FACILITY: SAN ONOFRE NUCLEAR GENERATING STATION, UNIT NO. 1

SUBJECT: SUMMARY OF MEETING HELD AT ONE WHITE FLINT NORTH ON MAY 7, 1990, RE:  
THERMAL SHIELD REPAIR

**TECHNICAL PRESENTATION**  
**ON**  
**THERMAL SHIELD SUPPORT SYSTEM REPLACEMENT**  
**AND**  
**CYCLE 11 MONITORING PROGRAM**  
**FOR SAN ONOFRE UNIT 1**

# New Thermal Shield Flexure Assembly

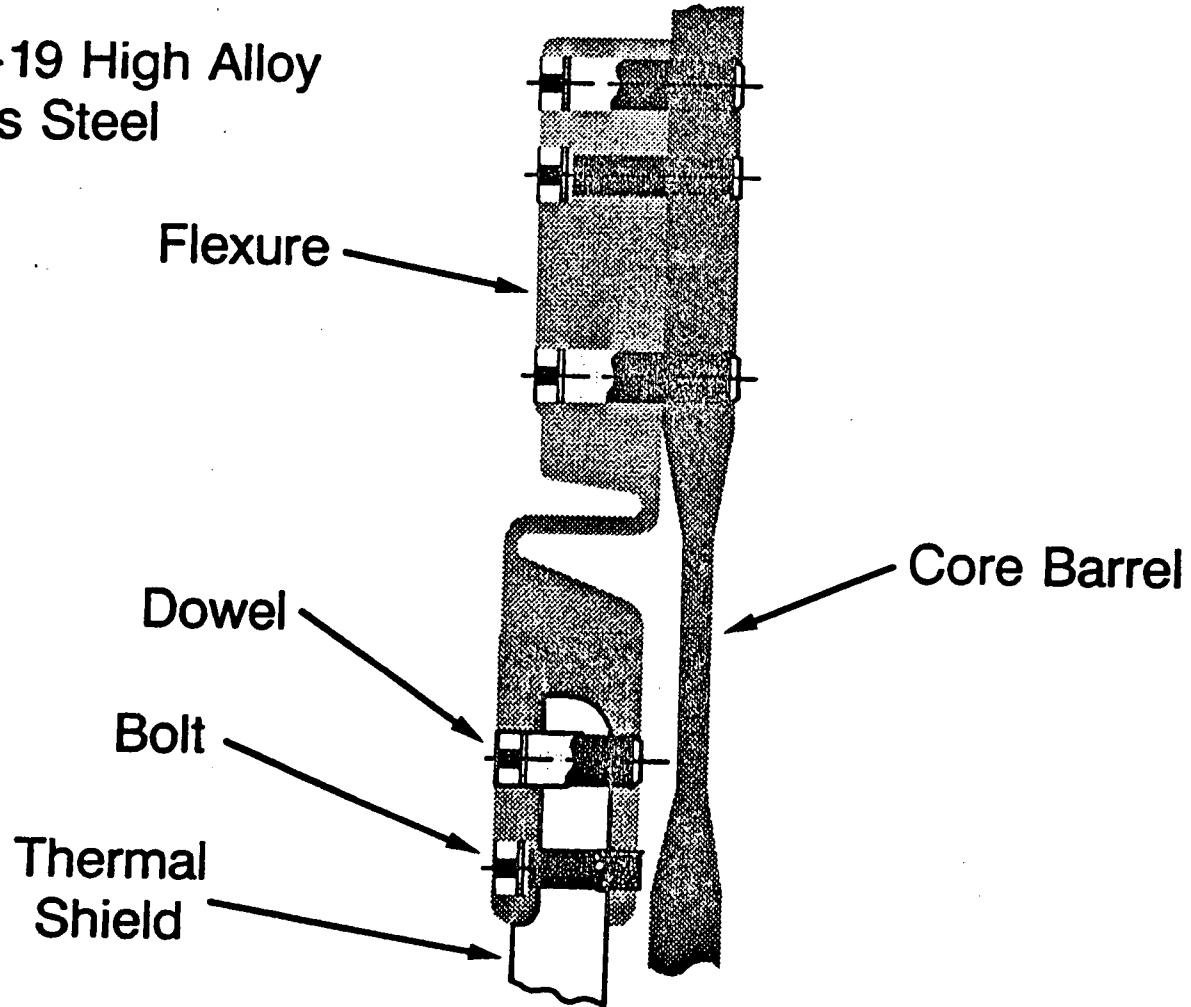
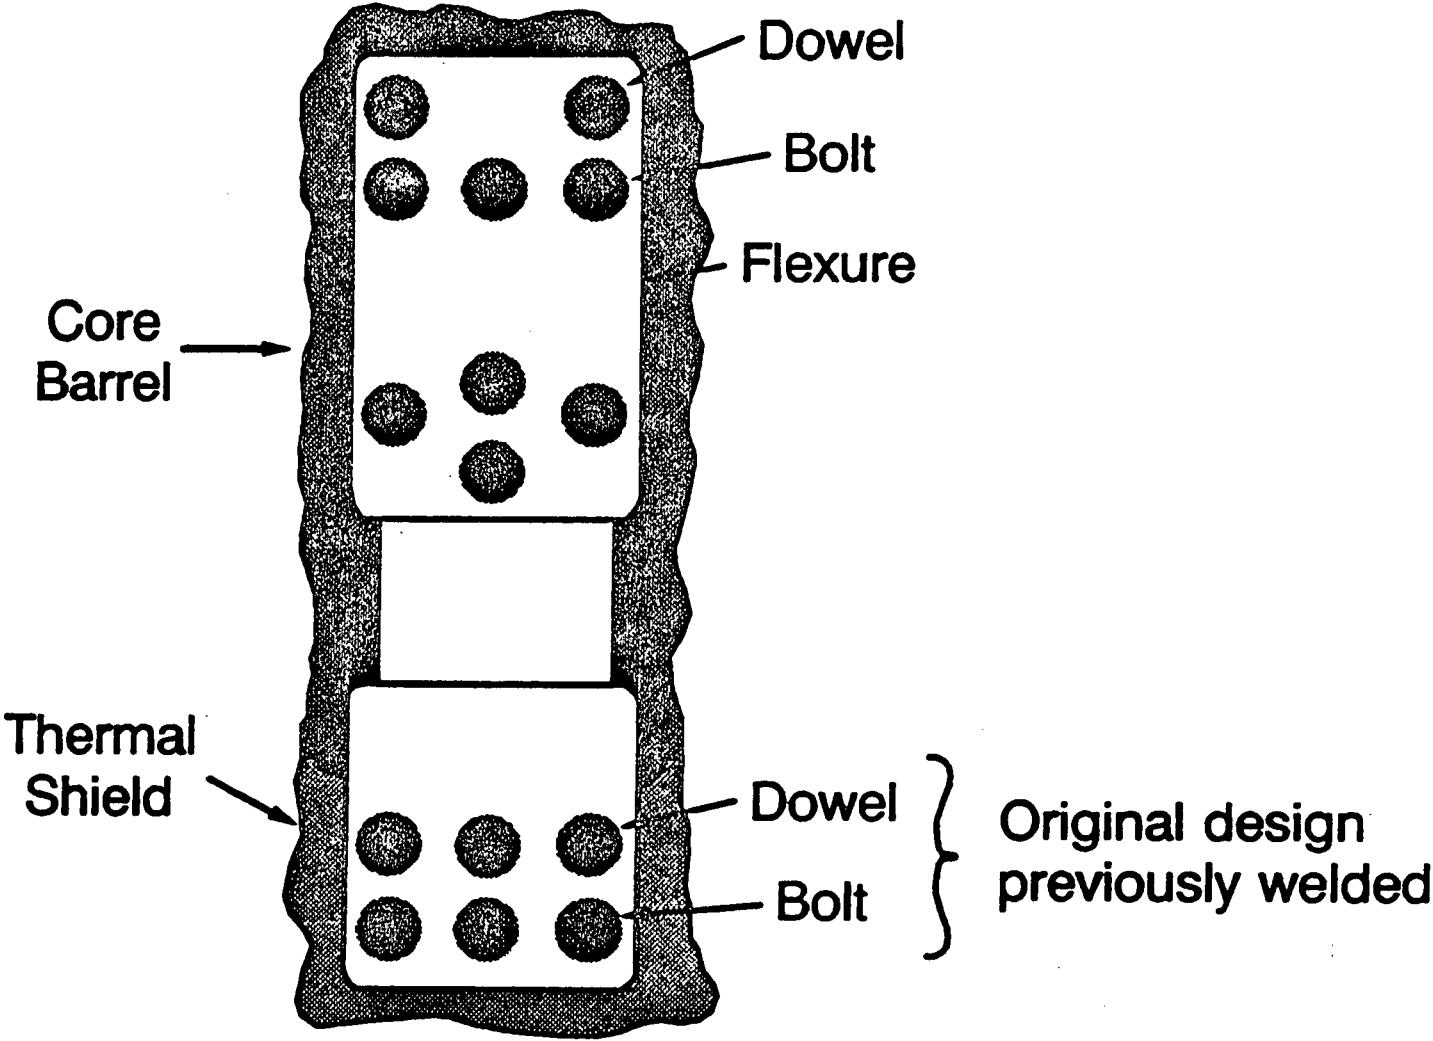
- Q Preloading will minimize stress in the flexure web area at operating temperatures and power levels. Is the operating condition used 92% power and reduced Tavg, or rated conditions? Will this impact the licensed power rating of SONGS 1 ?

- Q How does moving the location of one flexure reduce loading?
- A Analysis showed that moving the 21 degree flexure to 352 degrees reduced the stresses more than 10%.

- A Reduced temperature conditions were used for preload of the flexure. Preload will be established at 100% power with reduced Tavg. The design stress criteria will be met for 92% power and reduced Tavg.
